TOWN OF POMFRET
Selectboard

Memorandum of Decision

Property Address: 19 Dinsmoor Road
Pomfret, Vermont

PROJECT TITLE:	SHARED ACCESS ENTRANCE TO BARTLETT BROOK	PROJECT NO.:	2304	SHEET NO.:	C2.00	DATE:	6-13-23
SHEET TITLE:	PROPOSED IMPROVEMENTS PLAN - OPTION "A"

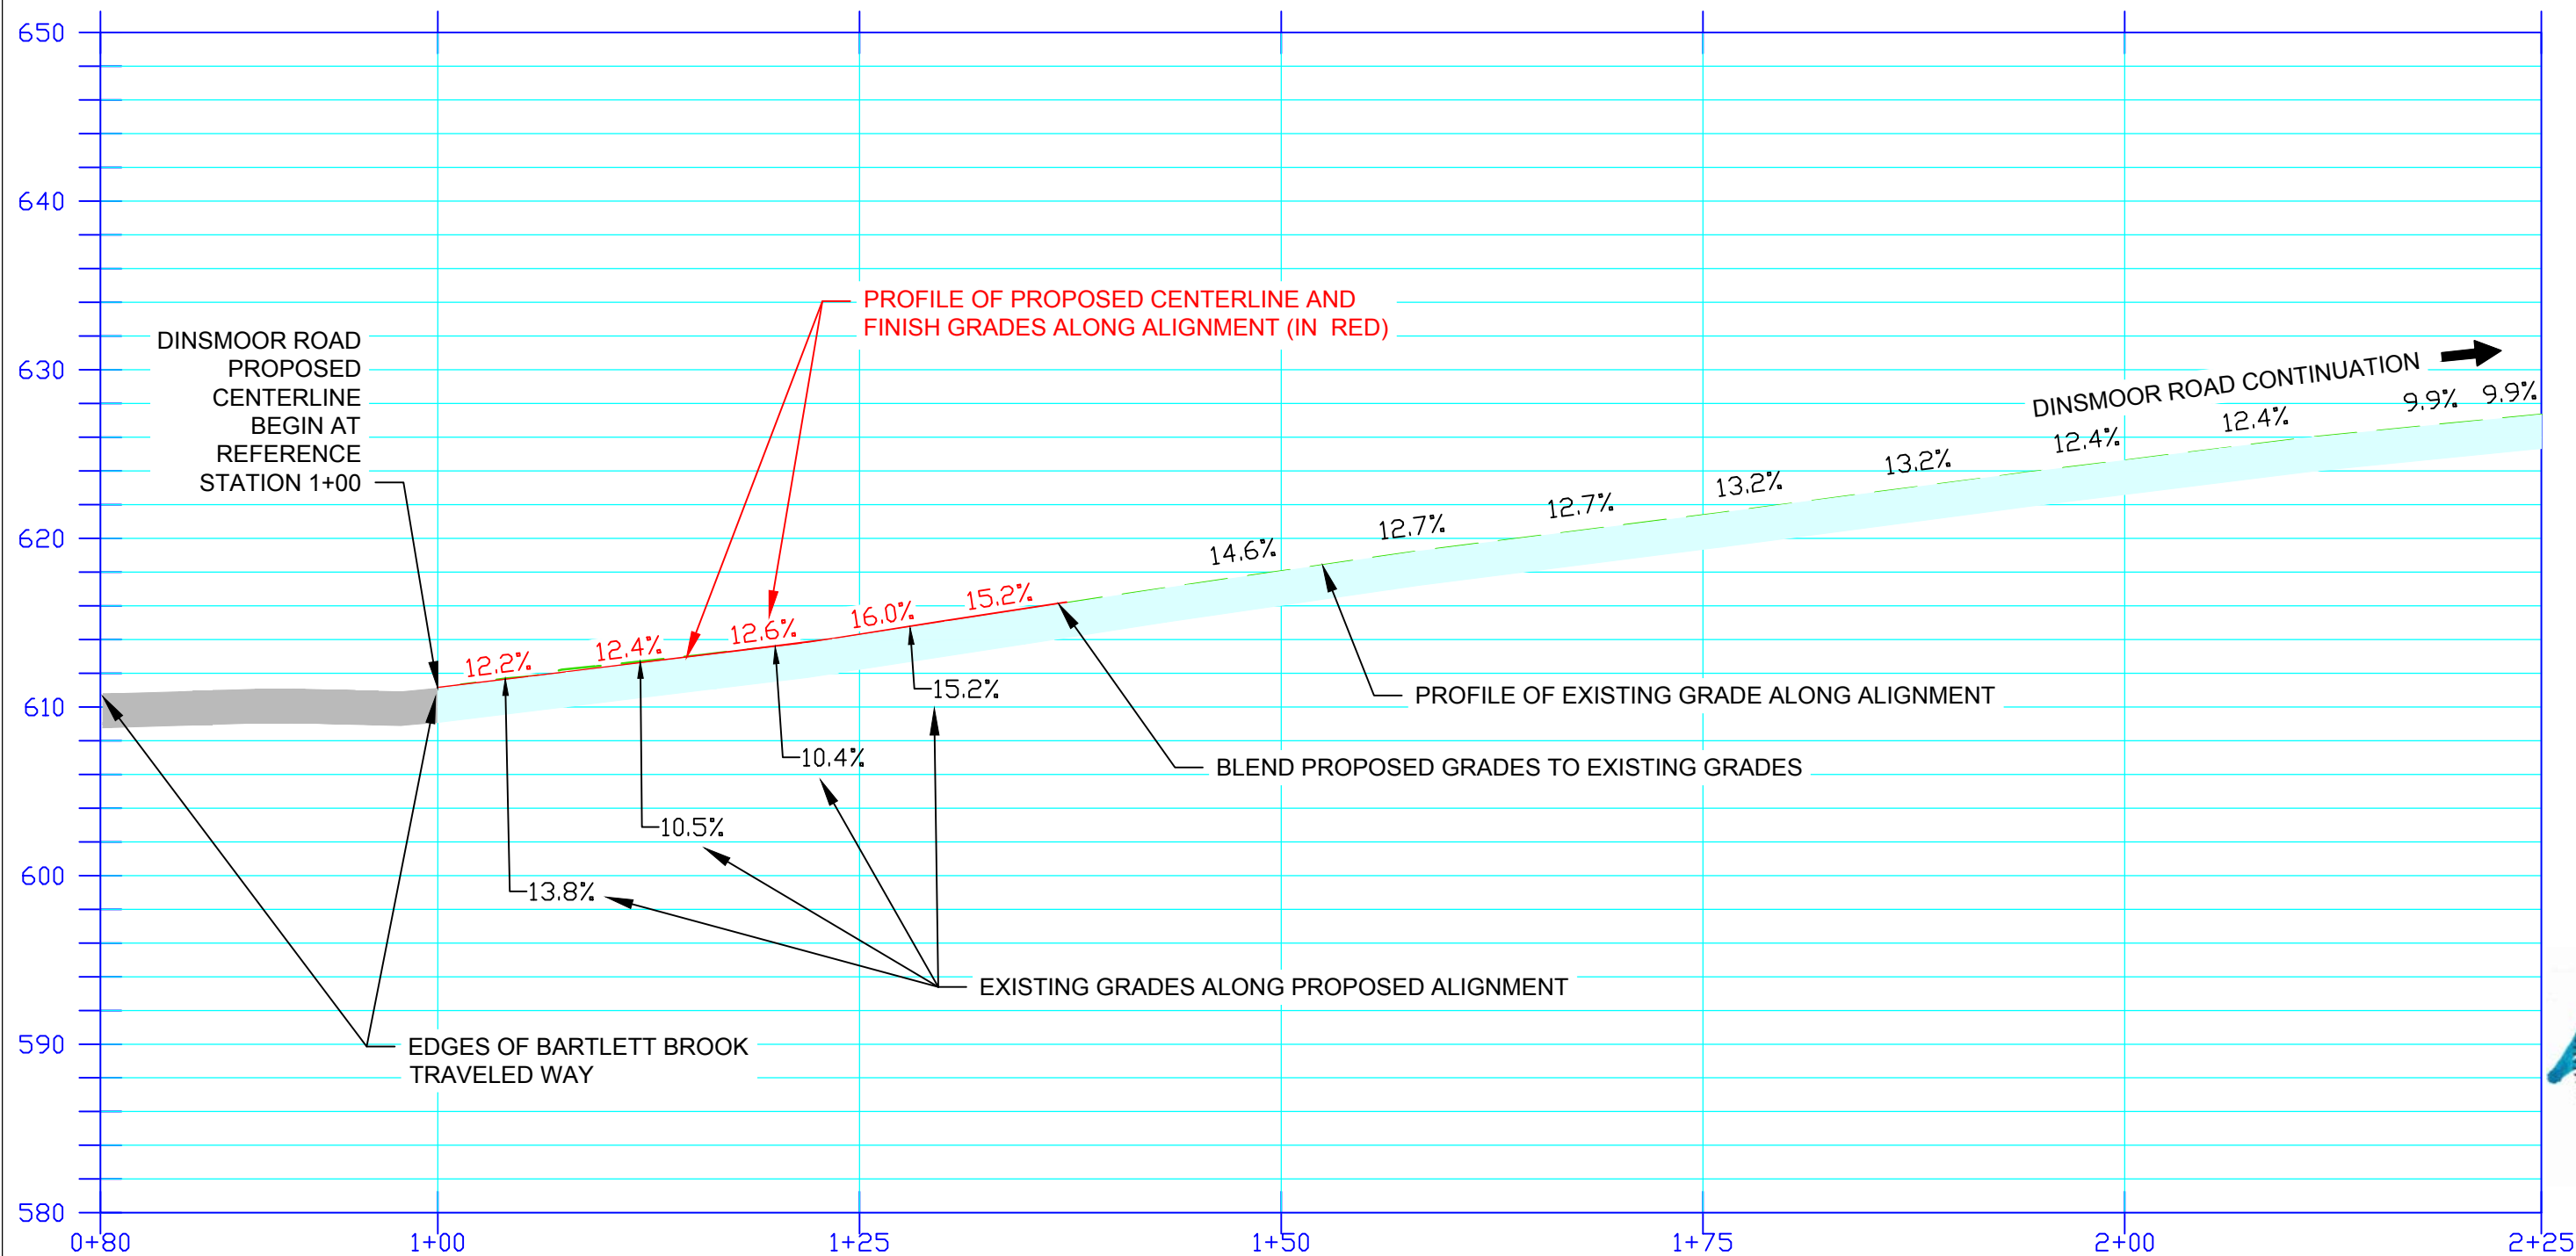
Based on the White Application, Construction Plans and testimony of witnesses, the Selectboard finds that the proposed modifications to Dinsmoor Road meet some but not all of the applicable standards set forth in the Highway Ordinance. The proposed modifications also raise concerns around the interests articulated in 19 V.S.A. 1111(b).

Although the proposed modifications would improve the existing skew angle intersection with Bartlett Brook Road, they would not create a 90-degree intersection. Vehicles entering onto and exiting from Dinsmoor Road still would need to make sharp turns, albeit through a wider turning radius than they do presently. As the proposed modifications would not reduce the existing grade, vehicles would remain at risk of overrunning the traveled way of Dinsmoor Road or Bartlett Brook Road, particularly in winter conditions, endangering the traveling public within the highway right-of-way.

While the Construction Plans provide for a drainage swale south of the proposed apron, the post-construction grade still presents a risk that runoff will enter the town highway during heavy rain events, causing erosion of the existing highway infrastructure. The apron, swale and headwall would occupy the area now used for driveway snow removal, increasing the likelihood that snow must be pushed into the highway right-of-way, further jeopardizing the highway infrastructure.⁷

Based on the White Application, Construction Plans, testimony of witnesses, the findings and conclusions described above, and **subject to the further limitations specified in Section V below**, a permit to construct a residential driveway is **denied**.
